REPORT FOR
**HIDDEN LAKE
SUBDIVISION**

COLEBROOK,
CONNECTICUT

Environmental Review Team Report

Colebrook Inland Wetlands Commission

100-year Flood Hazard Zone

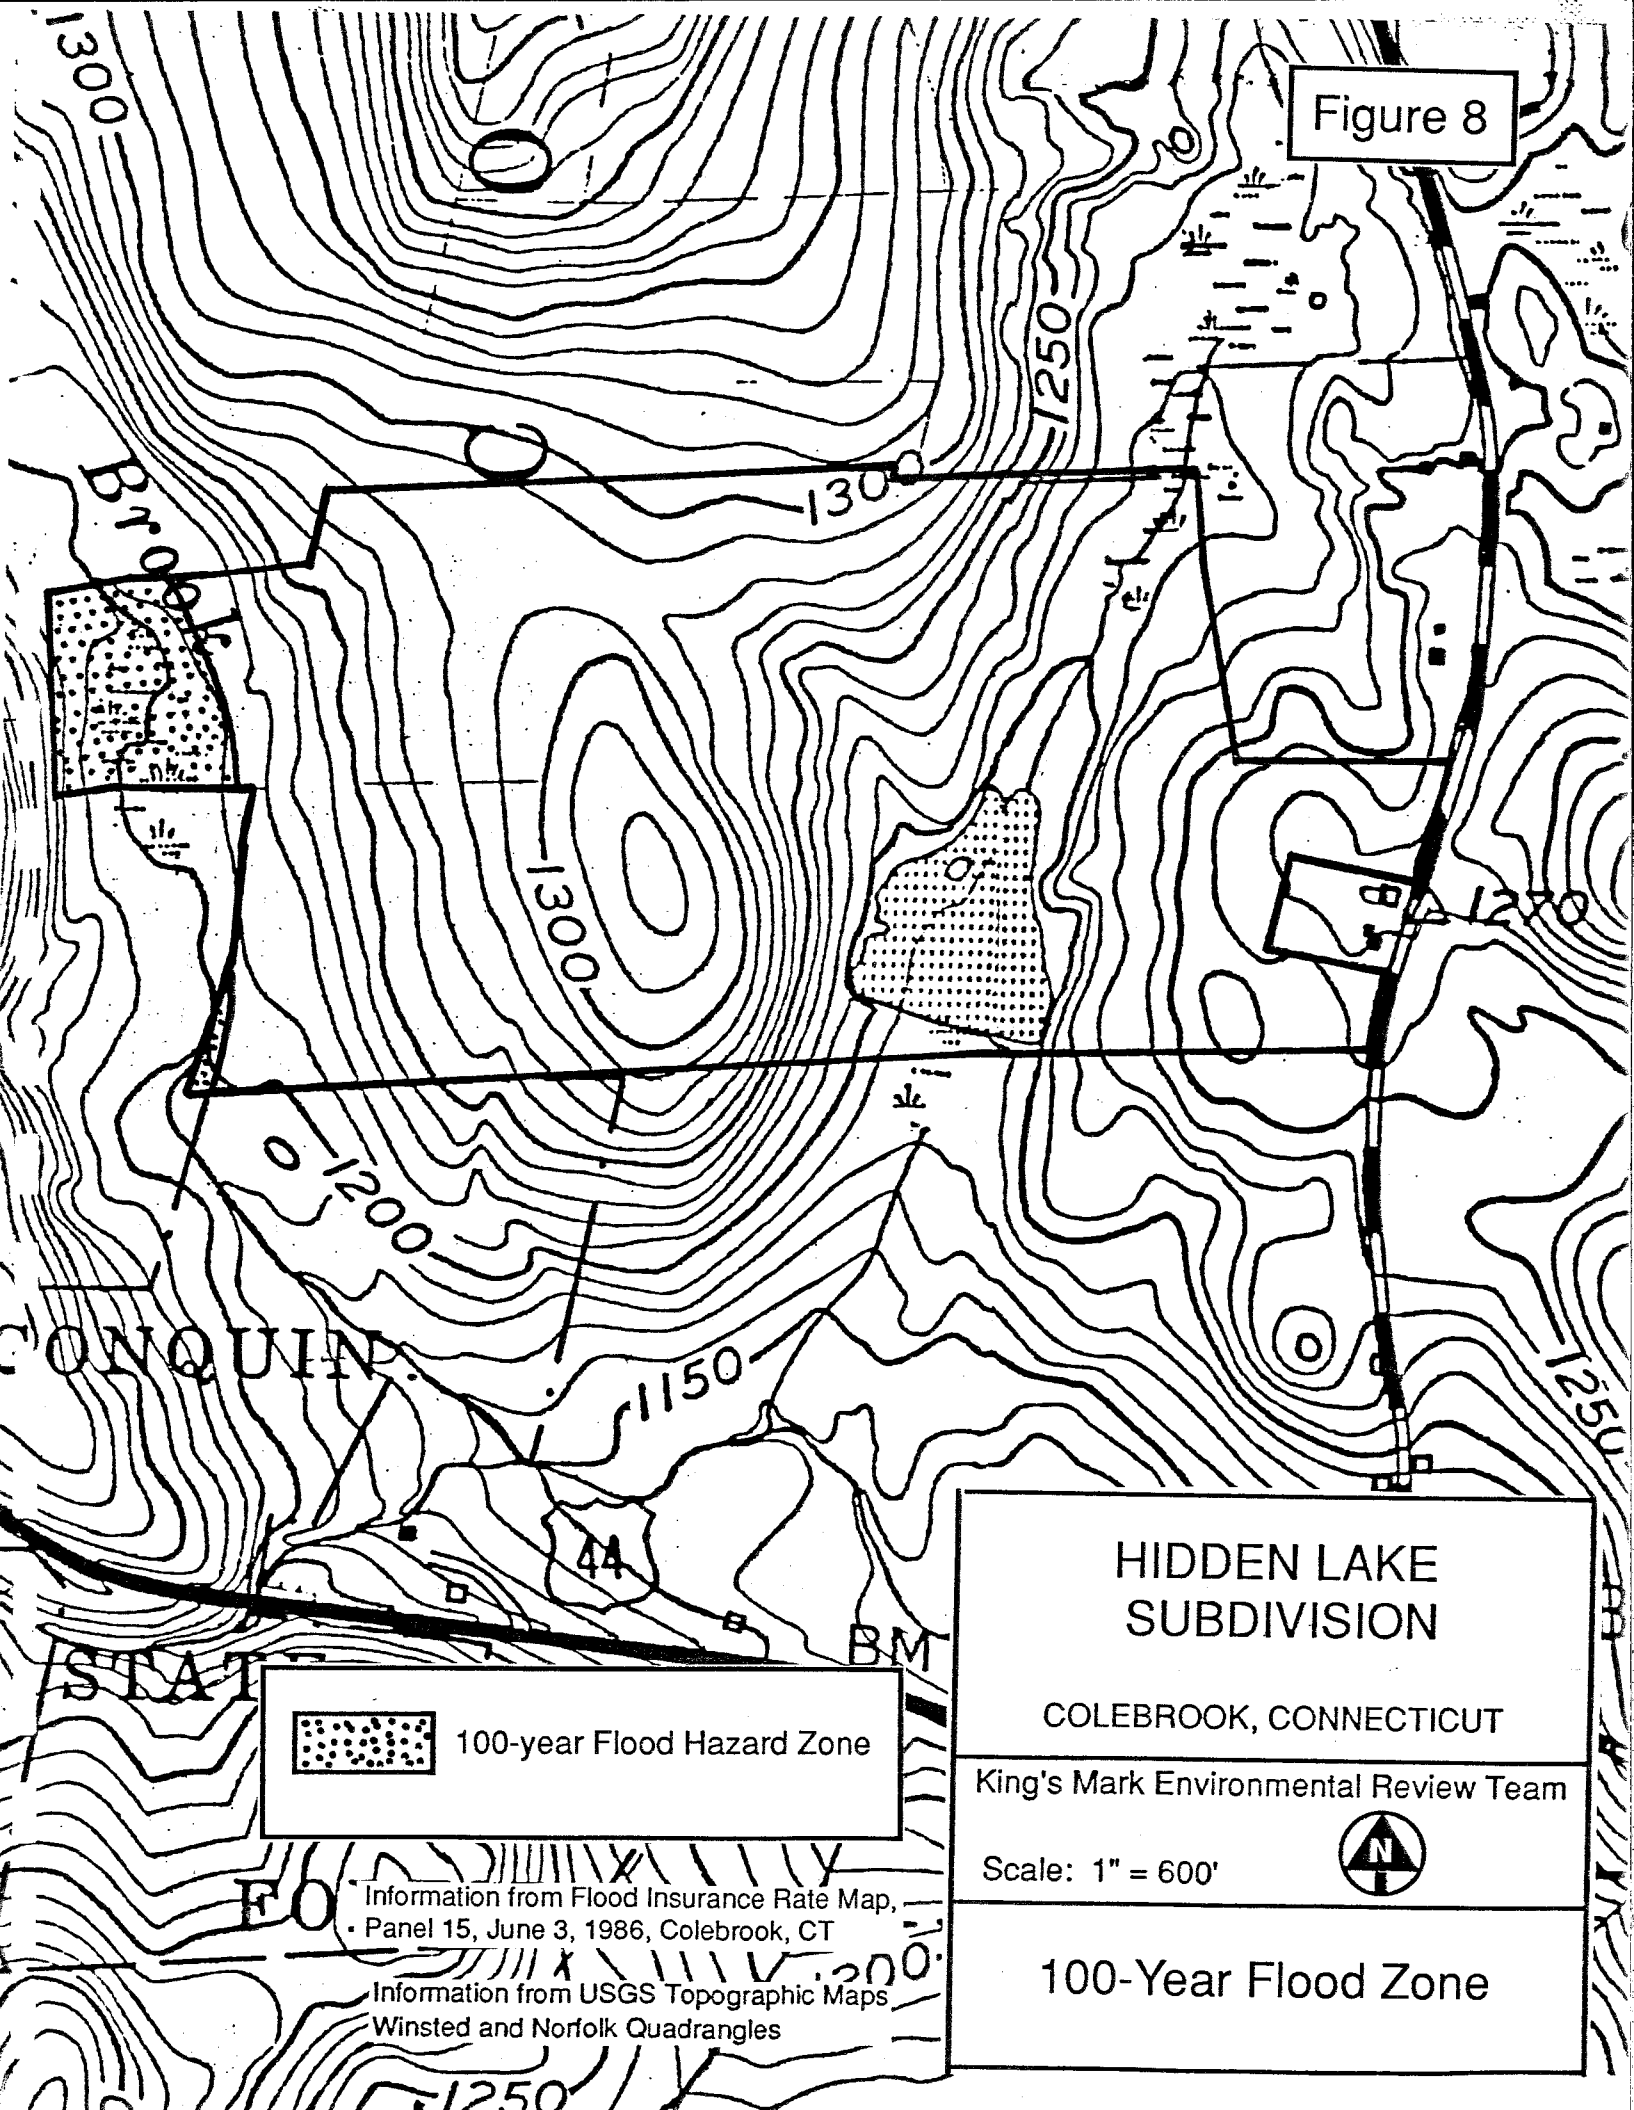
NFIP's Flood Insurance Rate Map, panel 15B, shows flood hazard areas on the site only for Mill Brook (Figure 8). This A zone area represents the flood boundaries of the flood having a 1% chance of occurring in any given year (the 100-year flood). Flood hazard areas have not been designated for Hidden Lake, the unnamed tributary feeding the lake or Beaver Pond because the size of their watershed is smaller than those normally considered by the NFIP. Furthermore, 100-year flood elevations have not been determined for the Mill Brook area or for any mapped flood hazard area in Colebrook, because the NFIP categorizes Colebrook as minimally flood prone and not having significant development plans along potentially flood hazardous streams or rivers.

The NFIP mapped flood hazard area existing for Mill Brook totals approximately 8 acres located in the westernmost section of the property in an area designated as open space. No development is planned within this mapped A zone.

A larger culvert and spillway design may be warranted to lower proposed flood elevations, especially for the proposed Forest Road crossing. Also, additional dam safety and hydraulic review is necessary through the DEP Dam Safety Unit (Hartford 566-7245) prior to determining if design plans are adequate.
